N9038A-05

S E R V I C E N O T E

N9038A MXE EMI Receiver

Reduce Unspecified Residual Responses Between 400 and 600 MHz

Figure 1 - Residual Responses

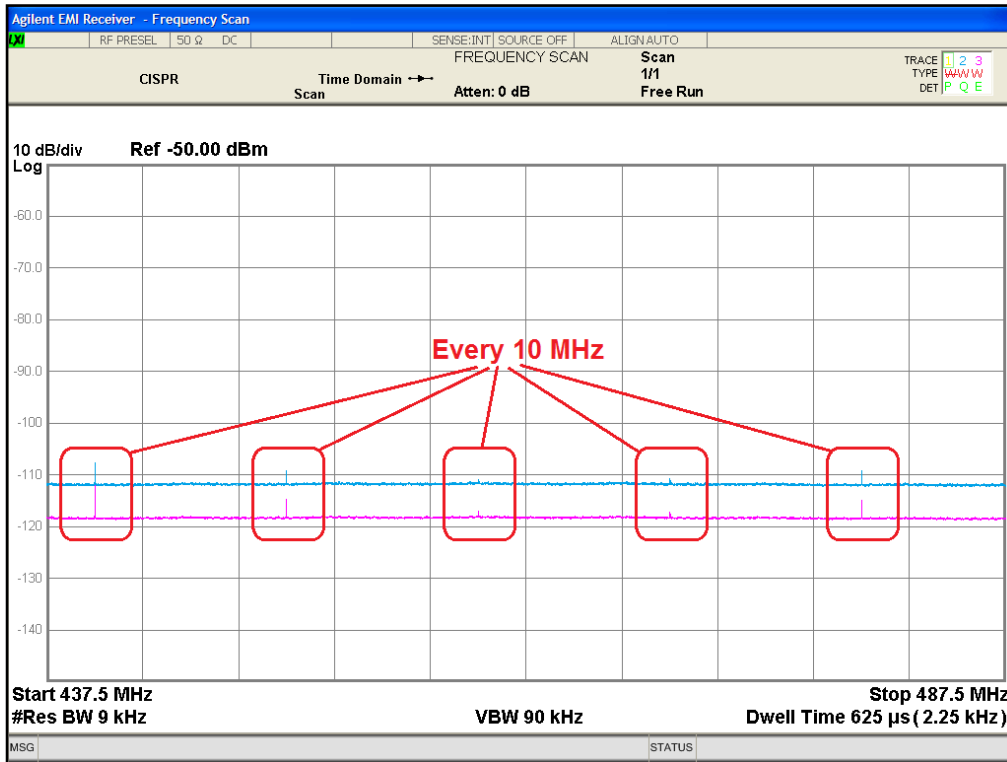
Some instruments have displayed residual responses due to multiples of the 10 MHz internal reference getting into the A22 Radiated Filter Board assembly, as shown in Figure 1. While these residual responses have never been seen high enough to violate any advertised instrument specification some users have reported that they interfere with the testing of their products.

To perform this modification two resistors will need to be changed on the A22 Radiated Filter board assembly and two capacitors will need to be added.

Figure 2 - System, Show, Hardware Display

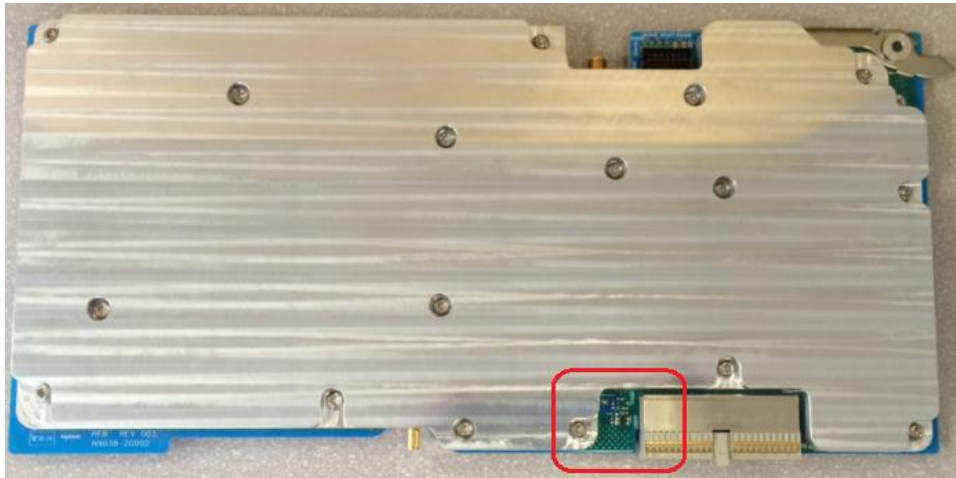
1. Verify that this modification has not already been performed by pressing **System, Show, Hardware** on the instrument and look for the material revision (Matl Rev) of the A22 Radiated Filter board assembly as shown in Figure 2.

2. If the material revision is greater than 7 stop here, the modification outlined in this service note has already been applied to this instrument.

If the material revision is 7 or less proceed to step 3.

Figure 4 - A22 Radiated Filter Board Assembly Component Locator

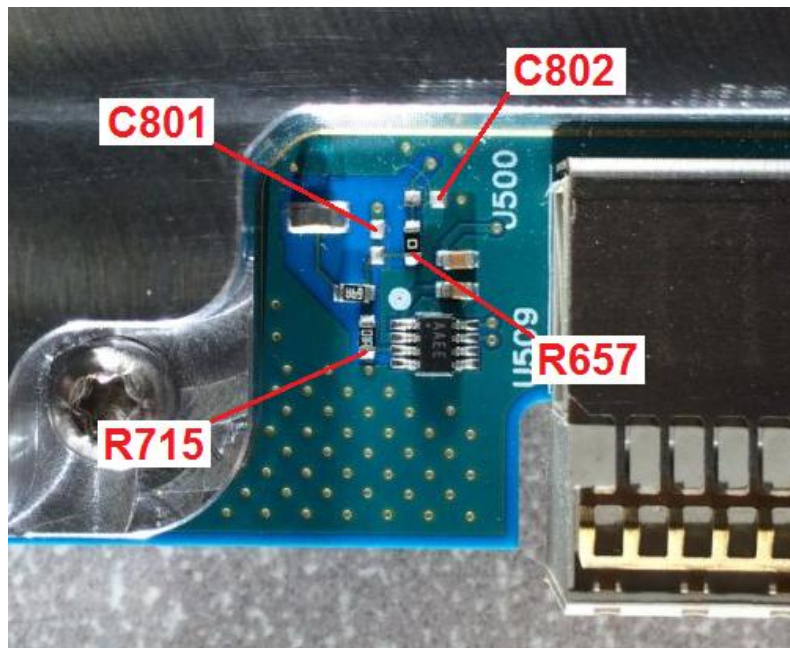
7. Referring to Figure 4, remove R657 and R715 and replace them each with a 49.9 Ω resistor, part number 0699-4509.

8. Referring to Figure 4, install a 47 pF capacitor (0161-1792) in the currently unused locations for both C801 and C802.
9. Carefully re-install the A22 Radiated Filter Board assembly into the instrument.
10. Install W34 between A21 J102 and A22 J100, and torque to 10 in-lbs.
11. Install the instrument top brace and torque all screws to 9 in-lbs.
